Response Supplement 1 to U.S. EPR Design Certification Application RAI No. 82

Response to
Request for Additional Information No. 82 Supplement 1

U. S. EPR Standard Design Certification
AREVA NP Inc.
Docket No. 52-020

Figure 06.02.01-12-1: Containment Pressure vs. Time for 59 Cases

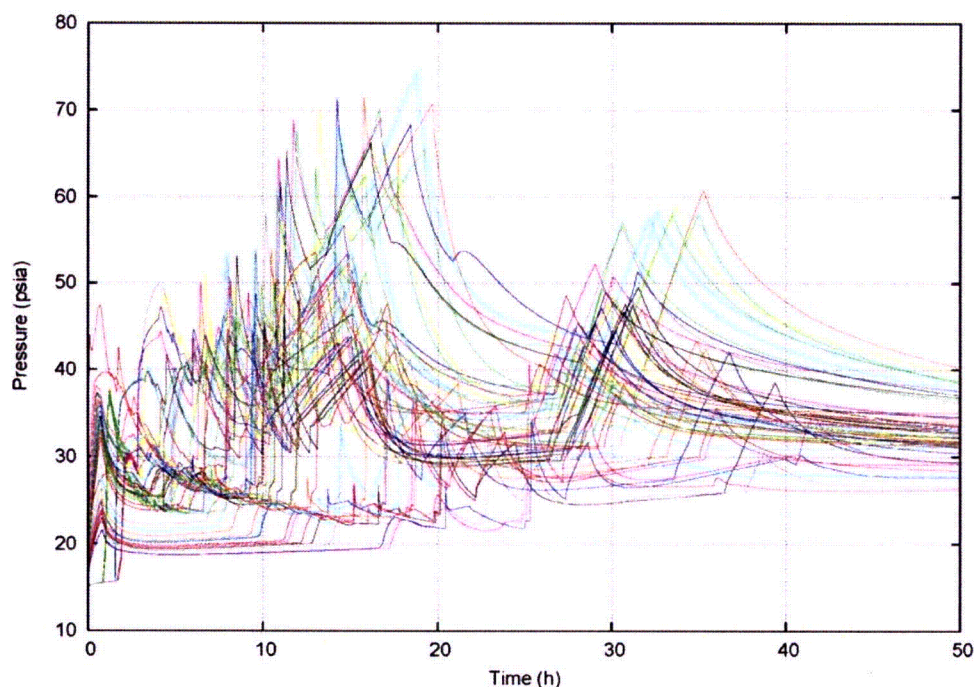
2. A sudden containment temperature reduction is said to produce the largest negative pressure of 2.92 psi which is said to be within the external design of the building. Provide the maximum negative differential pressure that would be within the structural design of the reactor building and provide reference to the FSAR section where the structural design is described.

AREVA NP performed an uncertainty analysis that included 59 separate cases to support containment performance following a severe accident. These cases are described in U.S. EPR FSAR, Tier 2, Section 19.2.4.2.3. As shown in Figure 06.02.01-12-1, none of the cases showed negative containment pressure. Therefore, the pressure response from these events is bounded by the sudden containment temperature reduction event described above.

Figure 06.02.01.03-1p: Comparison of ANS 1971 and ASB 9-2 Decay Heat Rates

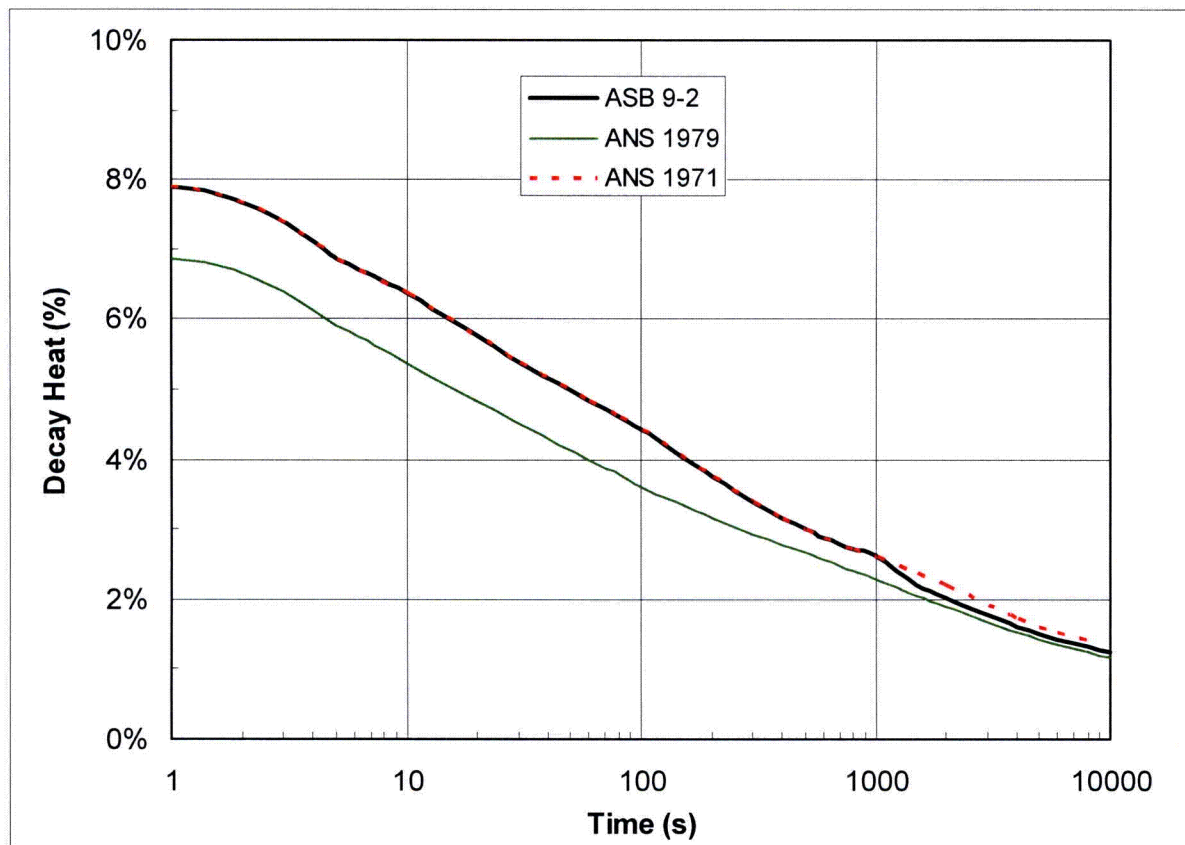
- p. Provide justification for decreasing the core decay heat multiplier from 1.2 to 1.1 in the mass and energy release calculations for the long term post reflood phase.

The core decay heat multiplier was defined in conformance with NUREG-0800 Branch Technical Position ASB 9-2. The ASB states that "In calculating the fission produced decay heat, a 20% uncertainty factor (K) should be added for any cooling time less than 10^3 seconds, and a factor of 10% should be added for cooling times greater than 10^3 but less than 10^7 seconds." The multipliers used in the LOCA mass and energy release model correspond to these uncertainty factors applied to the ANS 1971 decay heat curve.

The Standard Review Plan Section 9.2.5 references ANS 1979 as being acceptable for calculating the decay heat. A comparison of ANS 1979 decay heat rate with ASB 9-2 is provided in Figure 06.02.01.03-1p. The comparison shows that ASB 9-2 with 1.2/1.1 multiplier bounds ANS 1979 with a 2σ multiplier, where σ is the standard deviation set to 0.03 in accordance with AREVA NP's NRC approved realistic large break LOCA methodology. Additional information for the basis and the conservatism of the core decay heat rate used in U.S. EPR safety analyses is provided in the response to RAI 34 Question 15-7.

Figure 06.02.01.04.I-1: RELAP5 MSLB Noding Diagram

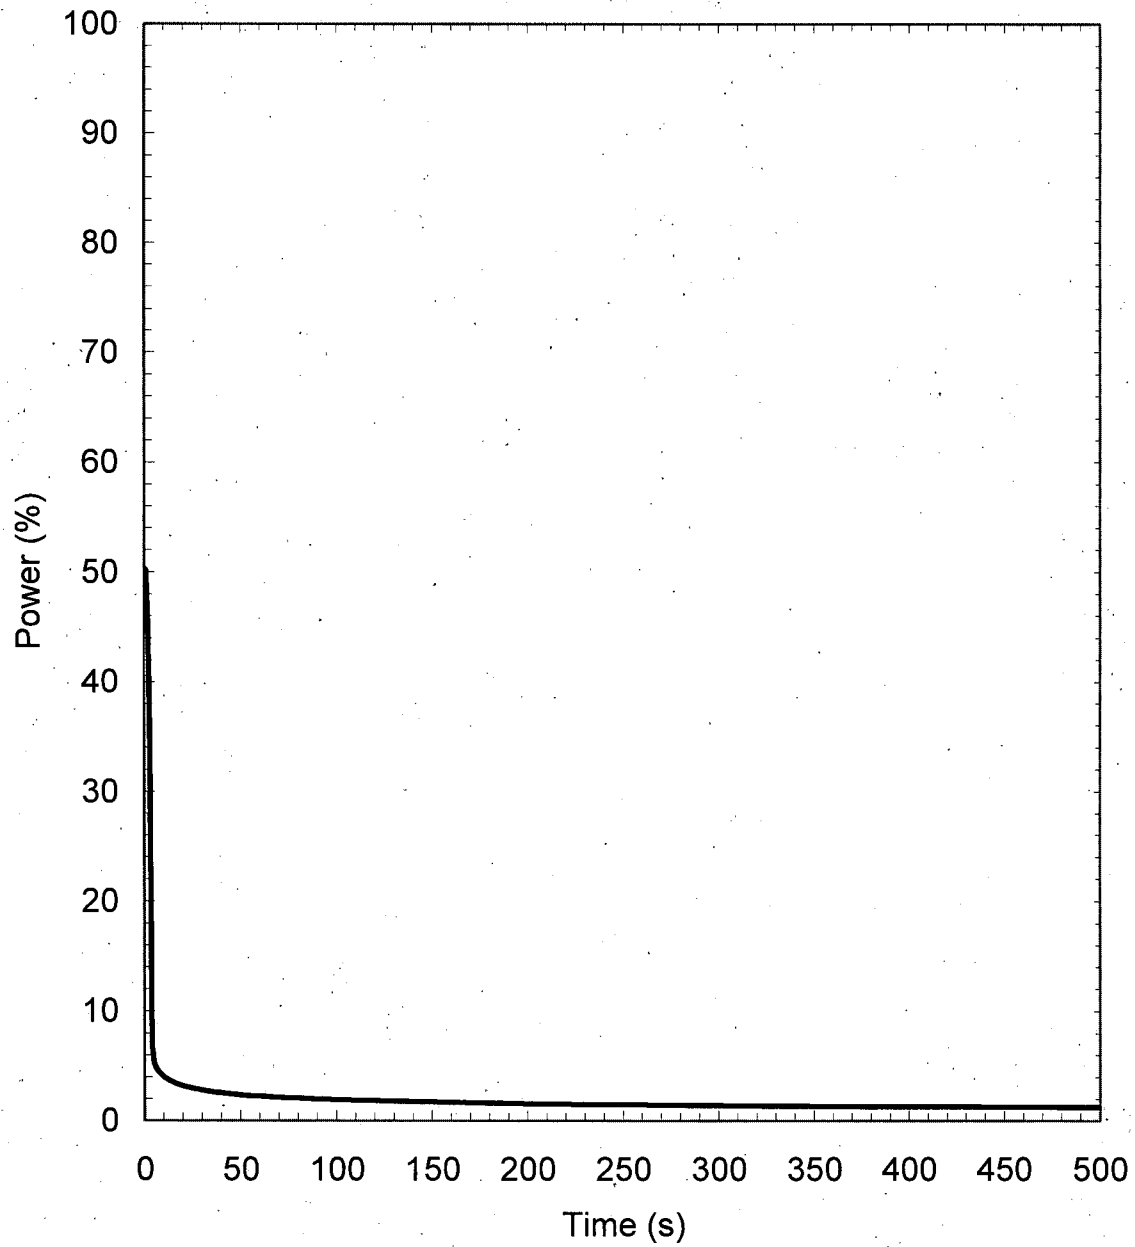
- k. Postulated feedwater Line Break Accidents were not addressed in FSAR Section 6.2.1.4. Provide evaluations of the containment consequences of postulated feedwater line break accidents.
- l. FSAR Section 6.2.1.4.2 states that the RELAP5 code was used to determine the mass and energy released during the blowdown. Provide a diagram of the RELAP5 noding diagram and justify that it is appropriate for EPR MSLB analyses.

The RELAP5 noding diagram used in the MSLB analysis is provided in Figure 06.02.01.04.I -1 through Figure 06.02.01.04.I -4.
